Final Decision Type I Staff Report

File number(s): DR 23-01
Project name: Hillyer Mid-City Ford Storage Building
Date of decision: May 19, 2023
Date of mailing: May 19, 2023
Applicant: Ronald James Ped Architect, PC
Landowner: Leo & Reyne Hillyer
Site location: 3000 Hillyer Lane
Tax Lot(s): 052W12C001100

Left: Excerpt from Marion County Assessor Tax Map 05 2W 12C
 Right: Aerial view of existing Hillyer Lane improvements

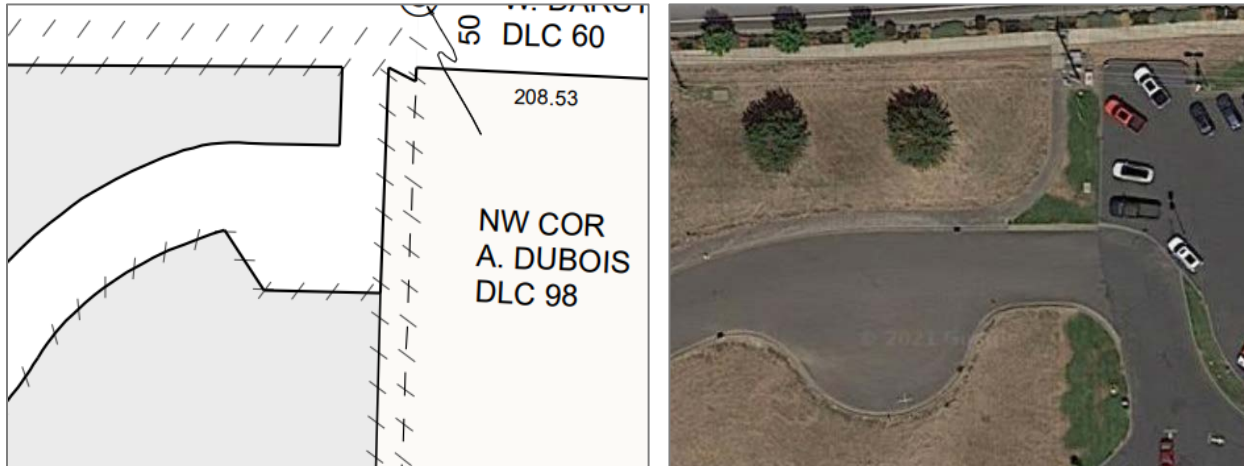
The subject property also has frontage at the end of Hillyer Lane. As can be seen in the excerpt from Marion County Assessor Tax Map 05 2W 12C below, this frontage includes a small stub connecting back to Newberg Highway.

Excerpt from DR 21-04 Staff Report as Final Decision Attachment 101 (north is left)

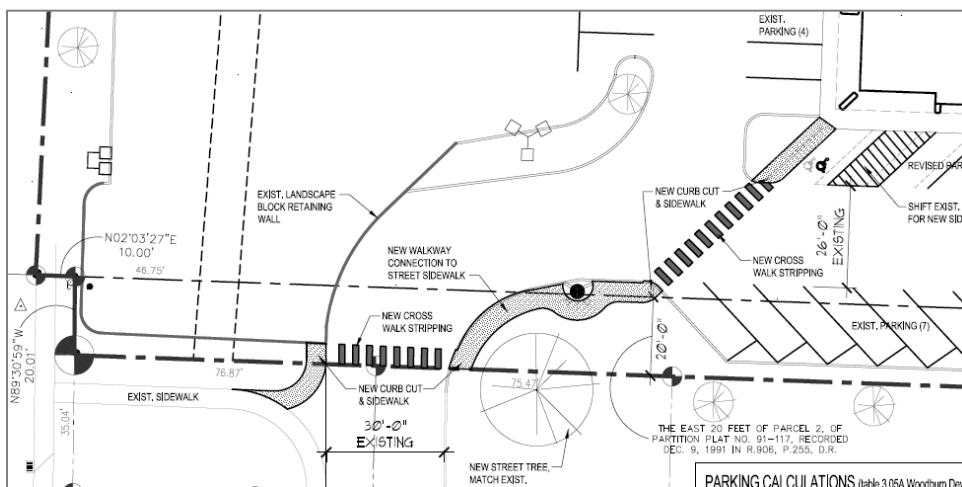
Hillyer Lane functions as a cul-de-sac / dead end street. A previous land use approval in the area (Preliminary Partition 2004-03) notes that Hillyer Lane was conveyed to ODOT in the early 2000s and improvements were completed in Fall 2002. Improvements consist of 34 feet of pavement along the street that ends in a turnaround bulb, with a 6-foot sidewalk along the north side of the street that connects back up to Newberg Highway within the ROW stub. As part of a recently approved Design Review for an expansion of the dealership (DR 21-04), a walkway connection between the building and the existing sidewalk was required (illustrated in the picture below). Staff considers this to be in substantial conformance with Figure 3.01G.

Regarding the small stub of ROW north of the cul-de-sac bulb, City staff received feedback from ODOT staff that this stub was never intended to serve as an intersection for vehicles between Newberg Highway and Hillyer Lane, it was intended to protect pedestrian connectivity and be used for utility purposes.

Figure 3.05C – Parking Space Striping

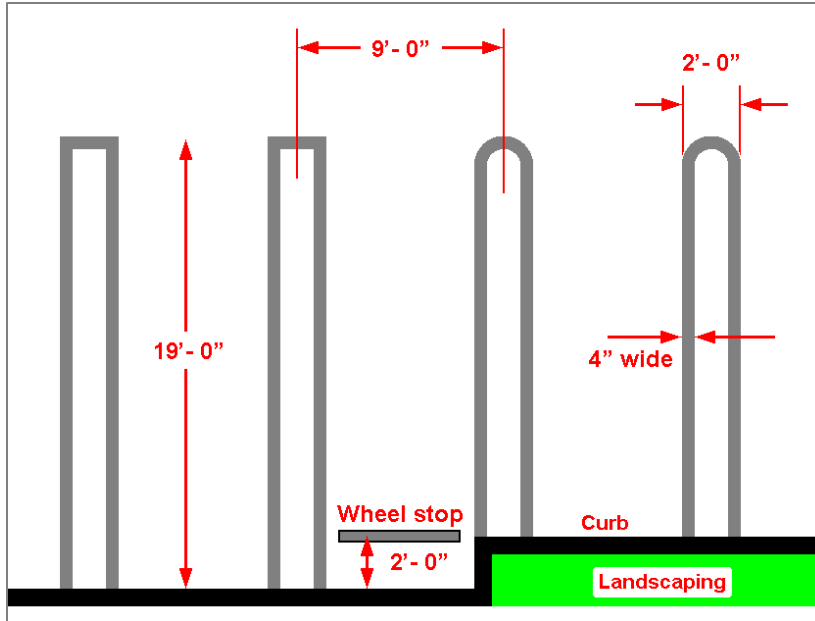
K. Except for dwellings other than multiple-family, off-street parking spaces shall be delineated by double parallel lines on each side of a space, except a side adjacent to any of curb or ADA parking accessible aisle. The total width of the lines shall delineate a separation of two feet. The lines shall be four inches wide (See Figure 3.05C).

- *Condition of Approval 4a*: 3.05.02D4 requires screening between outdoor parking/storage areas and public streets.
- *Condition of Approval 5a*: 3.05.02K requires all parking stalls be delineated by double parallel lines (illustrated by Figure 3.05C).

5. Parking: The developer shall revise plans to address the following parking items prior to building permit issuance.
 - a. Double parallel lines: To meet 3.05.02K and Figure 3.05C, all parking stalls shall be delineated by double parallel lines.
 - b. Carpool/vanpool parking: Stalls reserved for carpool/vanpool parking shall meet the striping and signage requirements in 3.05.03H.
 - c. Electric vehicle parking: Pursuant to Table 3.05E, at least 5% of required parking stalls shall be electric vehicle parking stalls with charging stations to meet the provisions within 3.05.03I.
 - d. Bicycle parking: Pursuant to Table 3.05D, at least 15 bicycle parking spaces shall be provided. Bicycle parking shall meet the provisions within 3.05.06C.
